Intersection ID: 27369	Main Street: JORDAN_RAE_LN	Cross Street: MEADOW_RUN_LN	Location:	SE
ADA ID: 062388689ED0	Ramp Type: BlendTrans2	Initial Pass/Fail: Fail	Overall Compliance: No	Severity Score: 8.75

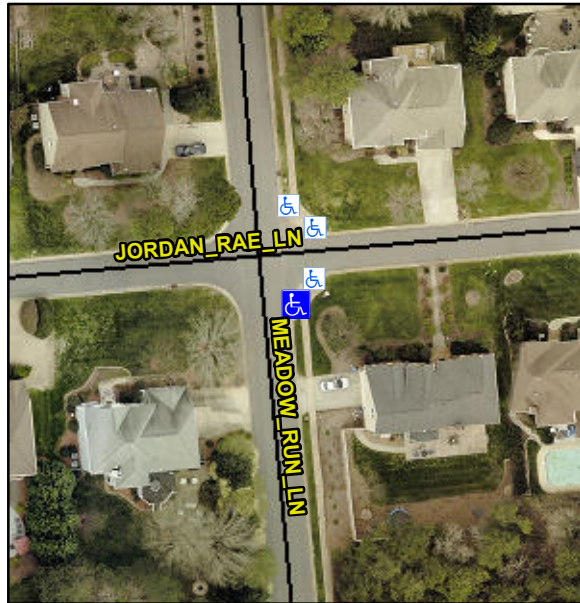
Not Found, R304.5.1

Compliance	Description	Data	Compliance	Description	Data
N/A	Ramp Length (in)	95.0	Yes	BlendTrans Slope (%)	3.4
No	Ramp Width (in)	40.0	Yes	BlendTrans XSlope (%)	0.4
N/A	Flare Type LT	N/A	N/A	Flare Type RT	N/A
N/A	Flare Slope LT (%)	N/A	N/A	Flare Slope RT (%)	N/A
N/A	Flare Traversable LT?	N/A	N/A	Flare Traversable RT?	N/A
N/A	Landing Length (in)	N/A	N/A	DWS Provided?	N/A
N/A	Landing Width (in)	N/A	N/A	DWS Contrast?	N/A
N/A	Landing Slope (%)	N/A	N/A	DWS Length (in)	N/A
N/A	Landing X Slope (%)	N/A	N/A	DWS Full Width?	N/A
N/A	Landing Curb? (Y/N)	N/A	N/A	DWS Offset (in)	N/A
N/A	Shared Landing?	N/A			
N/A	Gutter Ponding?	N/A	N/A	Gutter Slope (%)	N/A
N/A	Gutter Lip Ht (in)	N/A	N/A	Gutter X Slope (%)	N/A
N/A	Painted X Walk1?	No	N/A	Painted X Walk2?	N/A
	X Walk 1 Direction	To W		X Walk 2 Direction	N/A
	X Walk 1 Width (in)	N/A		X Walk 2 Width (in)	N/A
	X Walk 1 Slope (%)	7.6		X Walk 2 Slope (%)	N/A
	X Walk 1 X Slope (%)	0.2		X Walk 2 X Slope (%)	N/A

N/A	Ramp inside XWalk1?	N/A	N/A	Ramp inside XWalk2?	N/A
	Road Slope (%)	0.2		Clear Space?	N/A
	Road X Slope (%)	7.6	N/A	Clear Space to XWalk (in)	N/A
N/A	Any Obstructions?	N/A	N/A	Storm Grate/Utility Hazard?	N/A
	Obstruction Type			Storm Grate/Utility Type	
		N/A			N/A
			Yes	Surface Condition? (G/P)	Good
			No	Curb Slope (%)	7.8

Remove & Replace Curb Ramp With Two New Directional Ramps or Equivalent.
